FIELD SERVICE BULLETIN

FS-2019-02: Product Alert - FS 300 Hose Identification

Date: May 6, 2019
Model: All
Model Years: 1997 – 2019

Product Alert

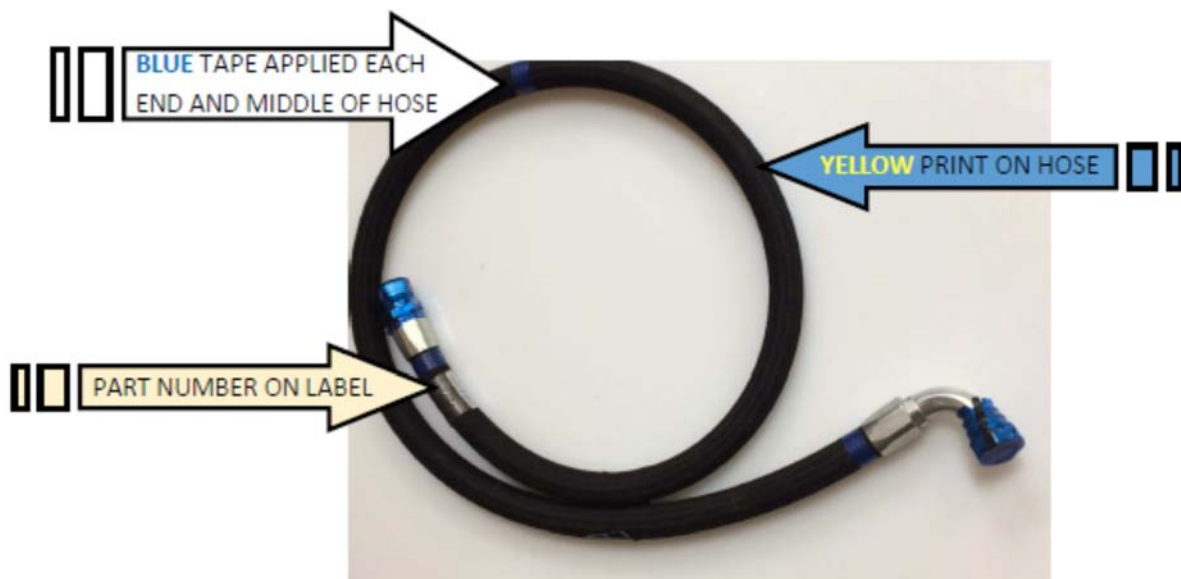
Gillig hose assemblies made with Eaton FC300 hose, which typically have a blue yarn cover will temporarily have a black cover.

Due to a supply issue with blue yarn Eaton is temporarily making FC300 hose with black colored yarn and applying yellow print instead of white print. The hose is otherwise identical to what has always been supplied and meets all specifications for use.

1. BLUE TAPE IS BEING APPLIED TO EACH ASSEMBLY AS A QUICK CHECK THAT IT IS FC300 HOSE
2. HOSE WILL HAVE YELLOW PRINTING INSTEAD OF WHITE
3. PART NUMBER ON LABEL WILL IDENTIFY THE CORRECT HOSE ASSEMBLY
